STAFF RECOMMENDATION

1707 Forrest Avenue

February 21, 2018

Application: New construction—addition; Partial demolition; Setback determination

Figure 2. Existing left façade. The existing addition is marked with the arrow

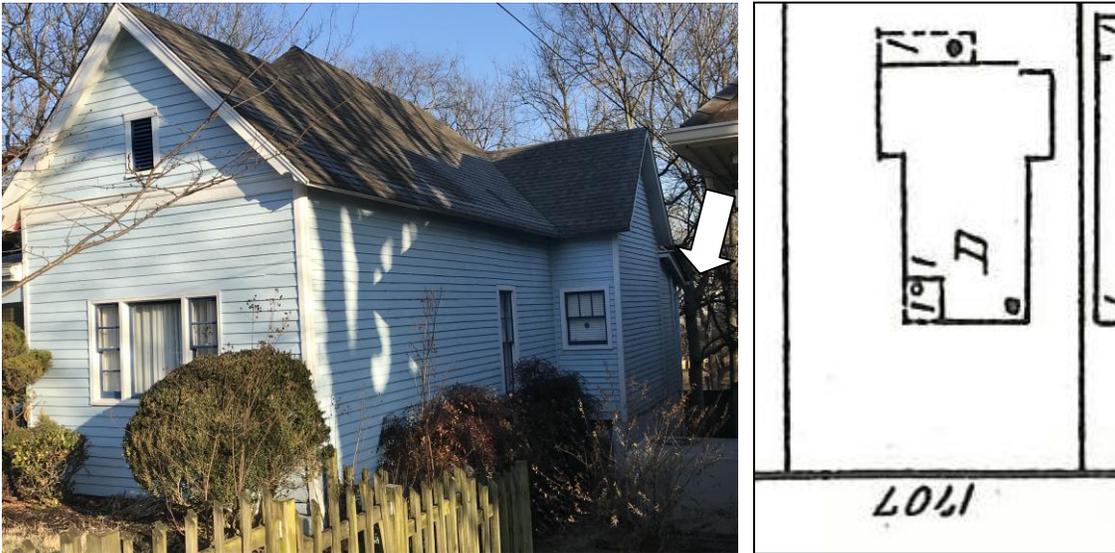
Partial Demolition: The applicant plans to alter the roof form of the non-historic part of the house at the rear (Figures 2 & 3). The date of construction of the existing shed-roof addition is not known; it has a different footprint than what appears on the 1957 Sanborn Map (Figure 4). Since the addition was built after 1957, staff finds that it is not an architecturally or historically significant part of the house. Staff therefore finds that the demolition and alteration of the roof of the rear extension of the house meets Section III.B.2. and does not meet Section III.B.1. of the design guidelines.

Figure 5 shows the existing front curbecut and driveway.

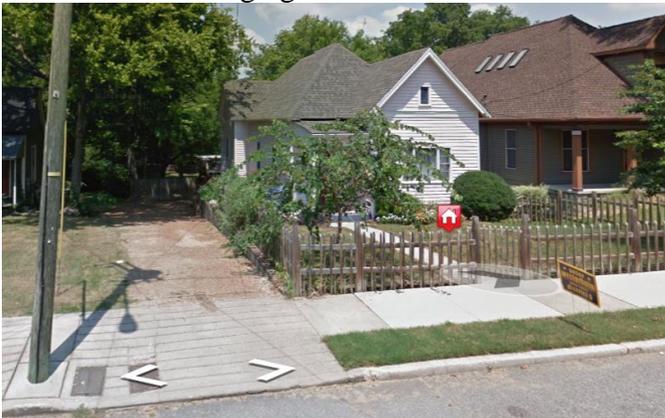
Orientation: The proposed addition will not affect the house’s orientation towards Forrest Avenue. The site does not have alley access, and the applicant will extend the existing driveway to the rear of the addition to access the attached garage at basement level (Figure 5). Staff finds that the addition’s orientation meets Sections II.B.6. and II.B.10. of the design guidelines.

01 SITE PLAN Scale: 1/16"=1'-0"

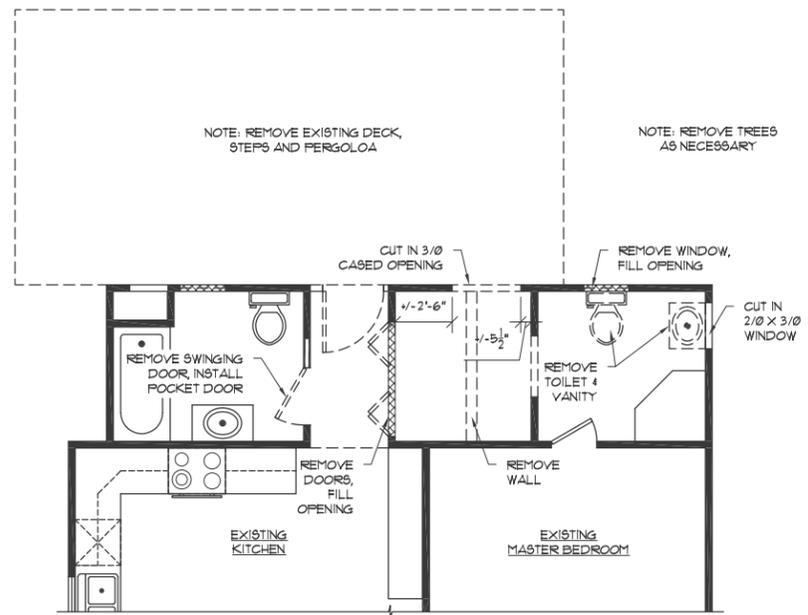
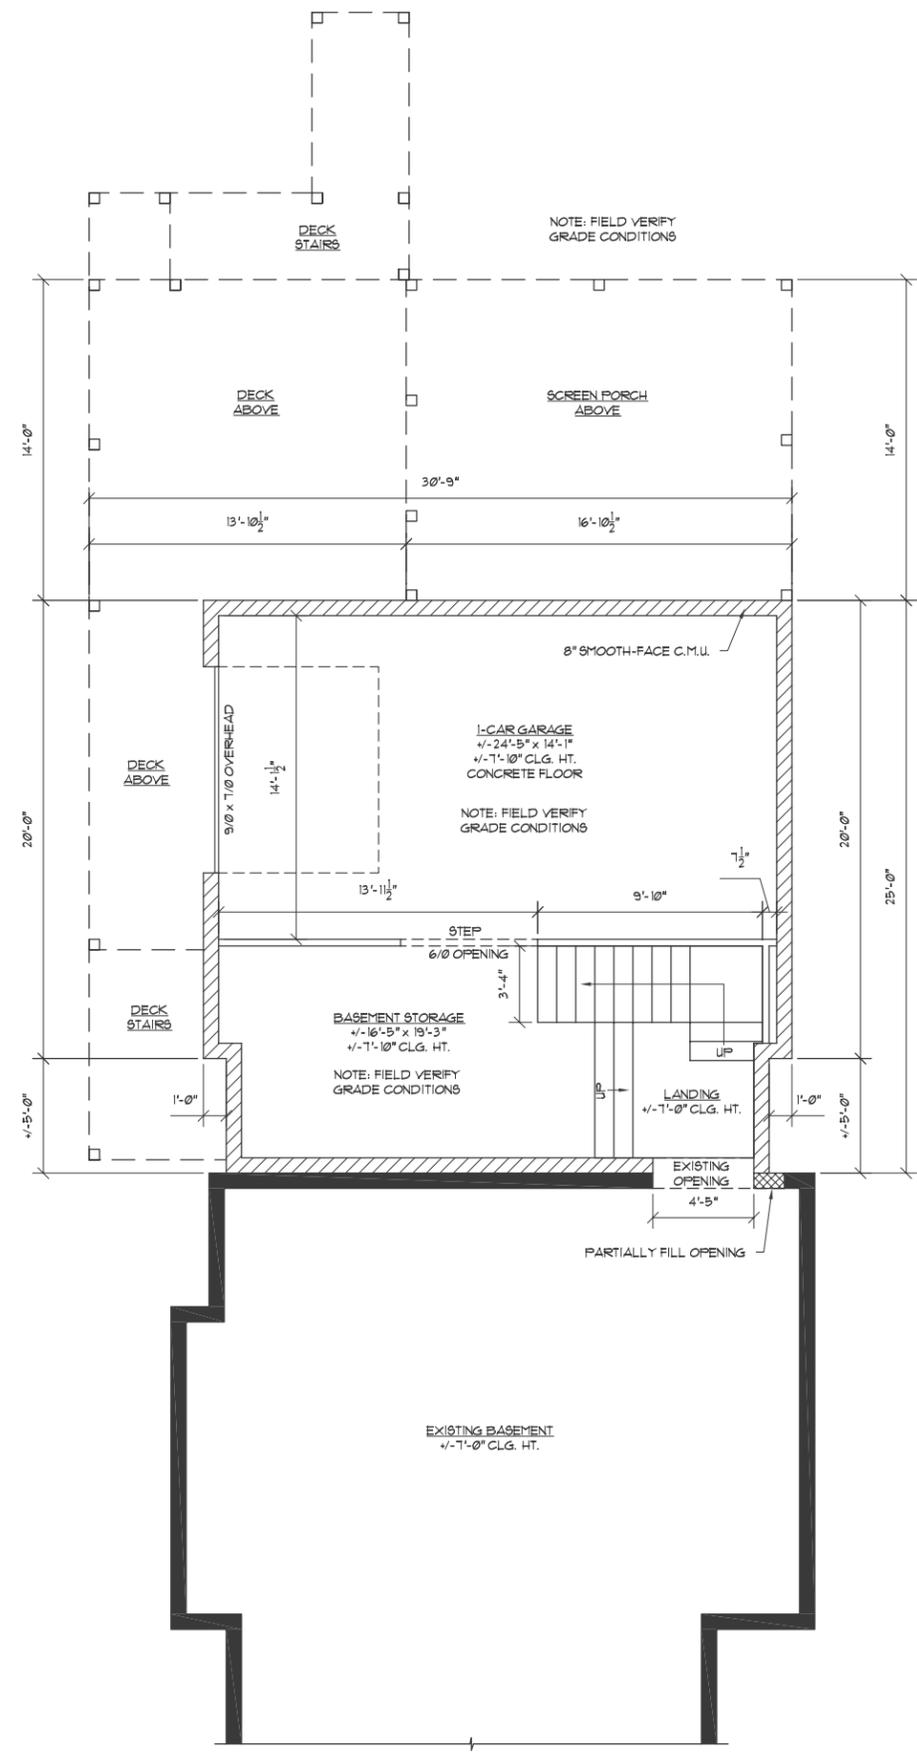
Setback & Rhythm of Spacing: The proposed addition meets the base zoning setbacks on the left and rear. It will be over twenty feet (20') from the left/west side property line and over one hundred and thirty feet (130') from the rear property line. On the right side, the existing house sits as little as two feet (2') from the side property line. The addition, at its widest, will be as little as three feet (3') from the side property line. The project therefore requires a change in setback from five feet (5') to three feet (3') on the right side. Staff finds the proposed setback to be appropriate because the addition is no wider than the historic house and is in fact inset from the historic house. Staff finds that the proposed addition meets Sections II.B.3. and II.B.10. of the design guidelines.
